FIELD CHANGE ORDER

Reference No. : 00 135 016
Date : August 2001
Product Group : 742

OPTIMUS 50 / 65 / 80

Error 00TH during tube adaptation

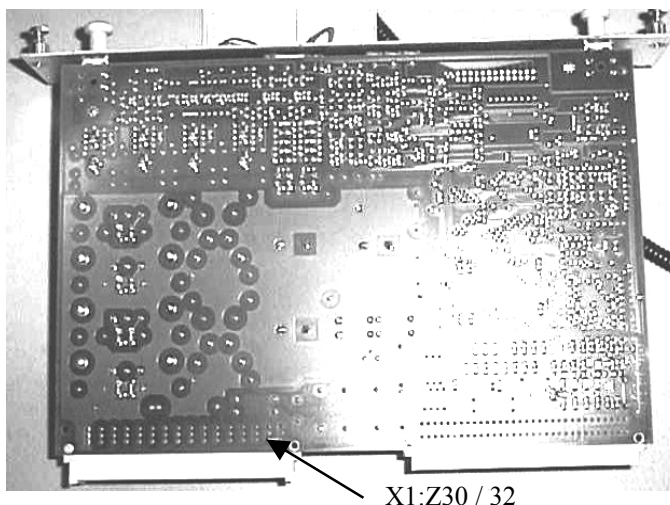
Symptom : Error 00TH during tube adaptation
Cause : The optocoupler B2 operates at its tolerance limits on board of PCB mA control EZ 119 (4512 108 05948). This can lead to intermittent problems during tube adaptation.
Remedy : Reduction of the input current for the optocoupler by soldering on an additional resistor parallel to the optocoupler diode.

1. Switch off the generator.
2. Open the cabinet, wait at least 1 minute, then pull out PCB EZ 119.
3. Solder on the resistor between contacts X1:B30 or Z30 and X1:B32 or Z32, see sketch for details.
4. Reinstall the PCB in the generator rack.
5. Close the cabinet.
6. Test all applicable functions.

Metal film resistor $\geq 0.25W$ 150 Ω / 1%
